PL2021-233
PL202100233

Metro Office Park
Bloomington, MN

METRO OFFICE PARK
SITE 3

METRO OFFICE PARK
SITE 1

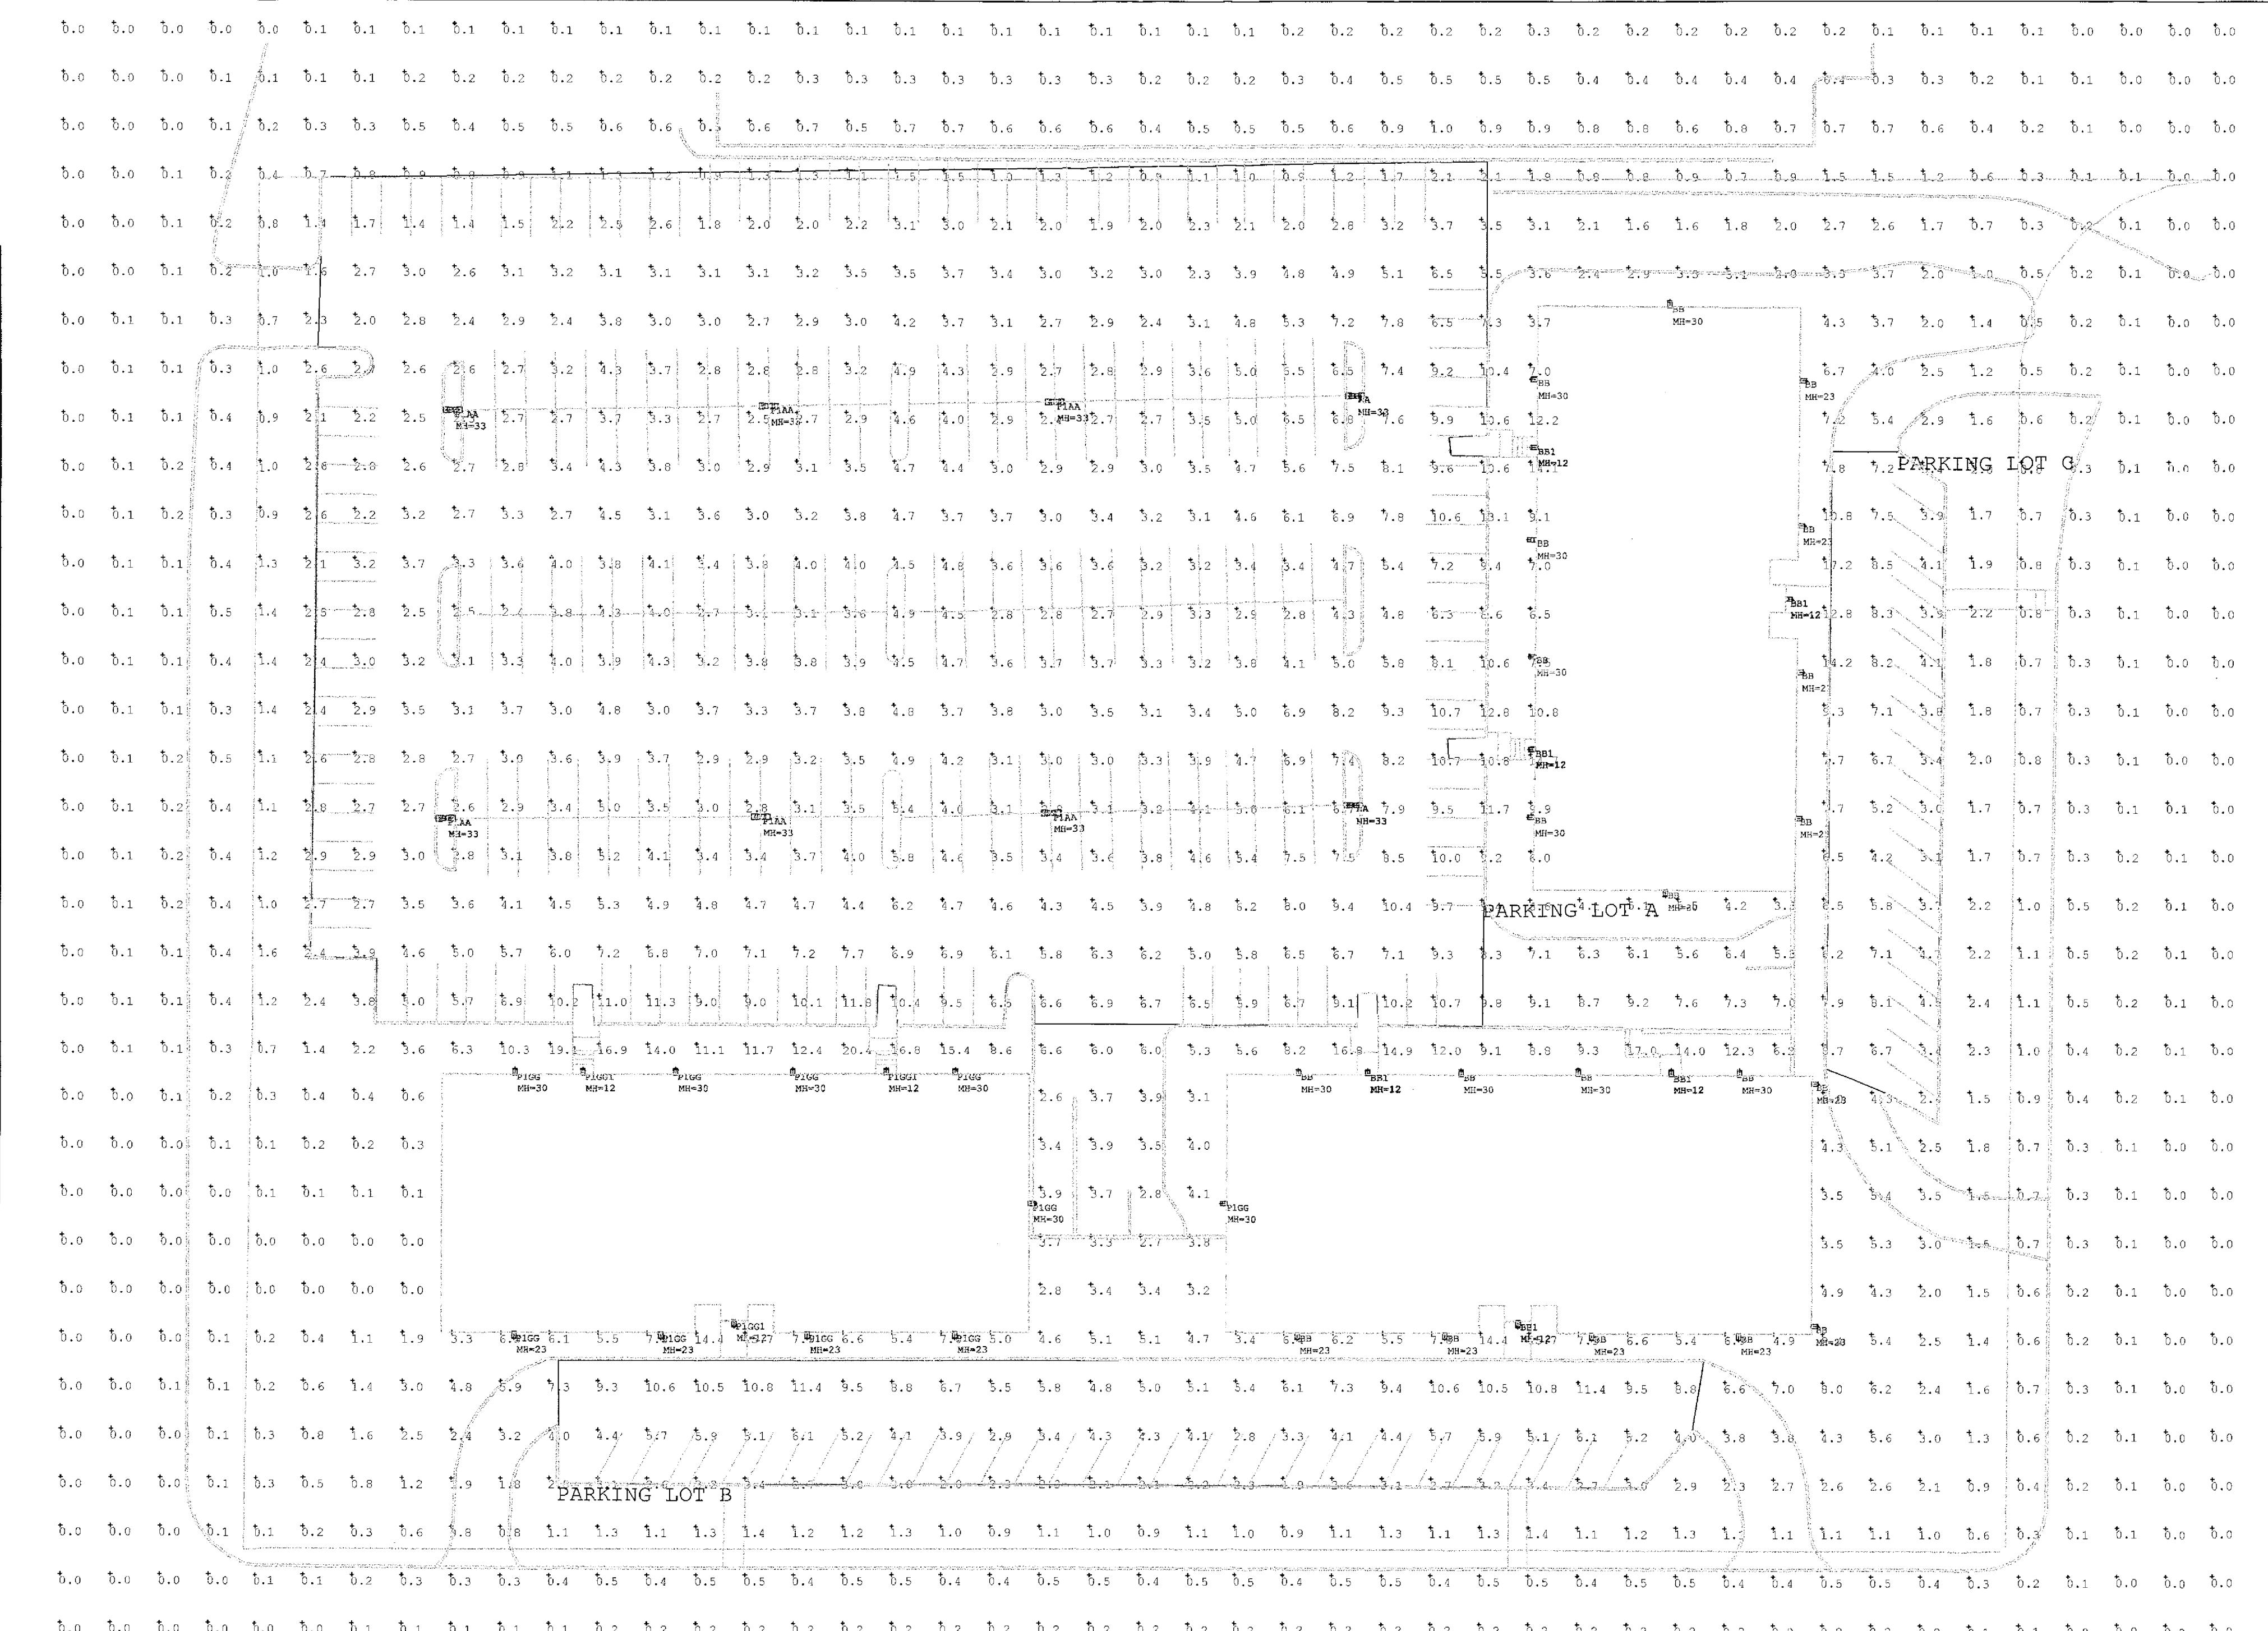
APPROVED WITH CONDITIONS

* All lighting levels are measured at ground level.

MUST call for installation inspections.

Prior to the installation, an inspection to verify the approved lamp, fixture, and pole heights must be completed. Before a Certificate of Occupancy may be issued, an inspection must verify compliance with the approved plan depicting the initial foot-candles levels. Individual points may not vary more than 20 percent with the average of all points within 10 percent of the initial foot-candle level on the approved plans. Any deviation beyond these criteria must be remedied prior to the issuance of a Certificate of Occupancy. CALL 952-563-8926 to schedule the inspections.

Your plan has been reviewed to the information presented. It is now subject to field inspection.

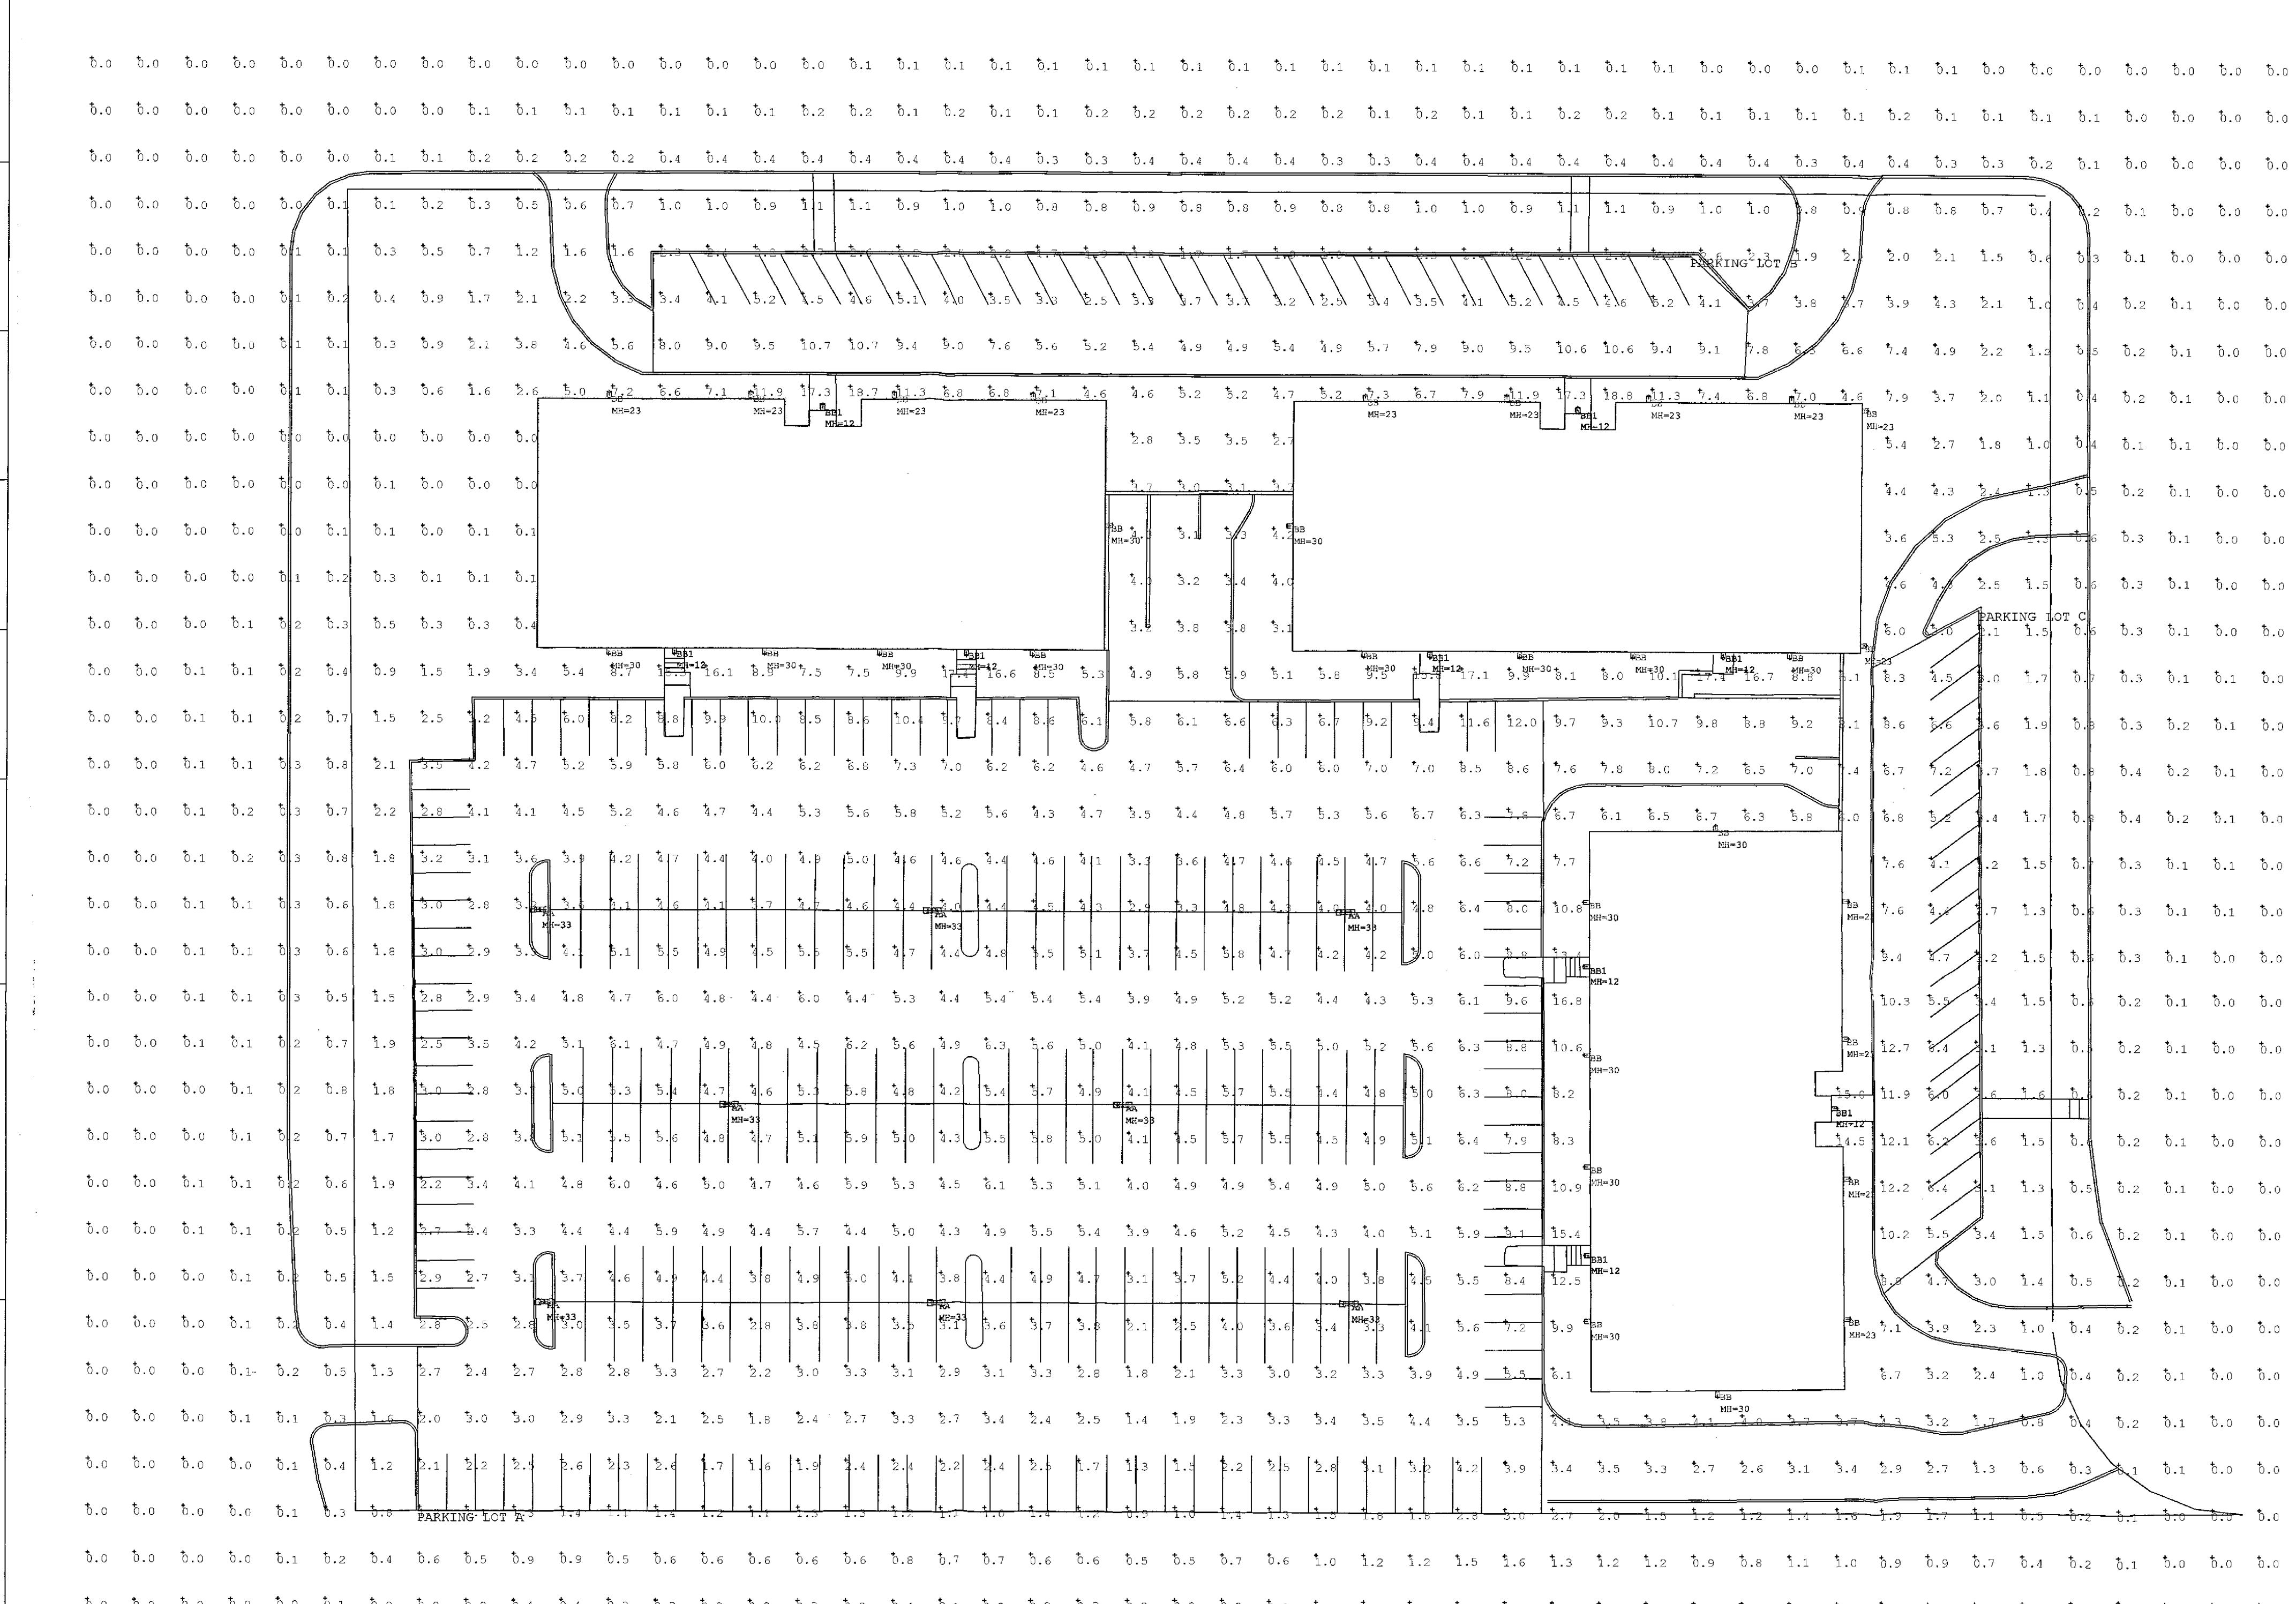
APPROVED WITH CONDITIONS

* All lighting levels are measured at ground level.

*** MUST call for installation inspections.**

Prior to the installation, an inspection to verify the approved lamp, fixture, and pole heights must be completed. Before a Certificate of Occupancy may be issued, an inspection must verify compliance with the approved plan depicting the initial foot-candles levels. Individual points may not vary more than 20 percent with the average of all points within 10 percent of the initial foot-candle level on the approved plans. Any deviation beyond these criteria must be remedied prior to the issuance of a Certificate of Occupancy. CALL 952-563-8926 to schedule the inspections.

Your plan has been reviewed to the information presented. It is now subject to field inspection.
